Proposal for Corrigendum 1 to Supplement 5 to the 02 series of amendments
Regulation No. 107 (M₂ and M₃ vehicles)

“Figure 30

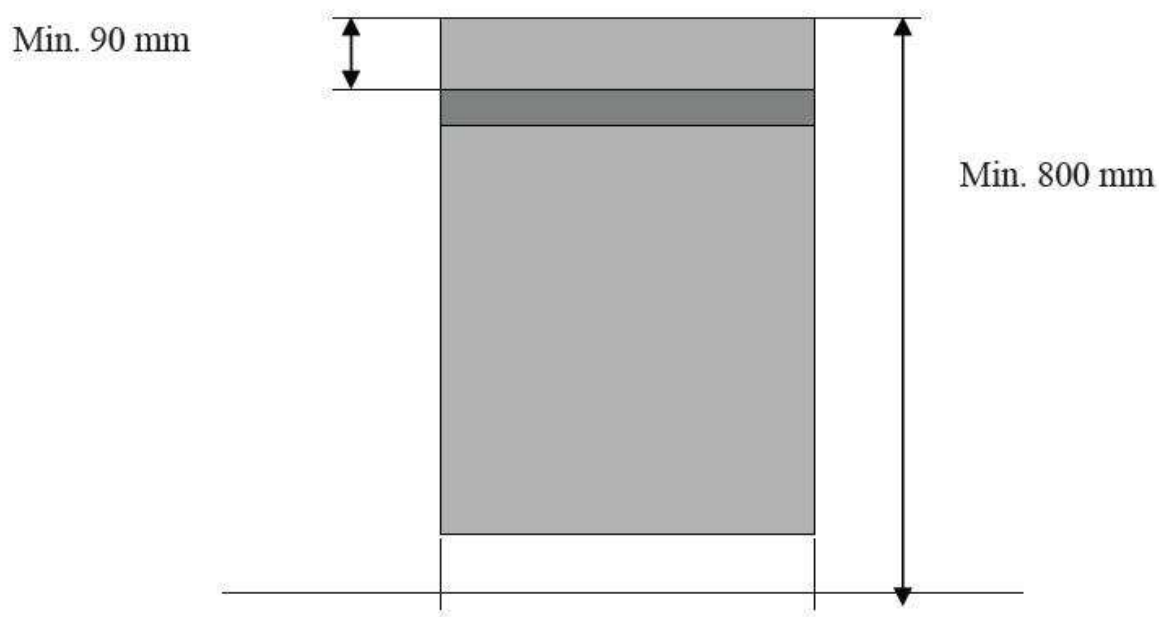
Annex 4, insert a new figure 30, to read:

This proposal aims at correcting Supplement 5 to the 02 series of amendments to Regulation No. 107. New paragraph 7.7.13.1.2 introduced by Supplement 5 makes reference to Figure 30 of Annex 4. However, this new figure 30 was omitted when Supplement 5 was prepared. Since Supplement 5 is based on GRSG-95-28, it is proposed to introduce the figure included in GRSG-95-28.
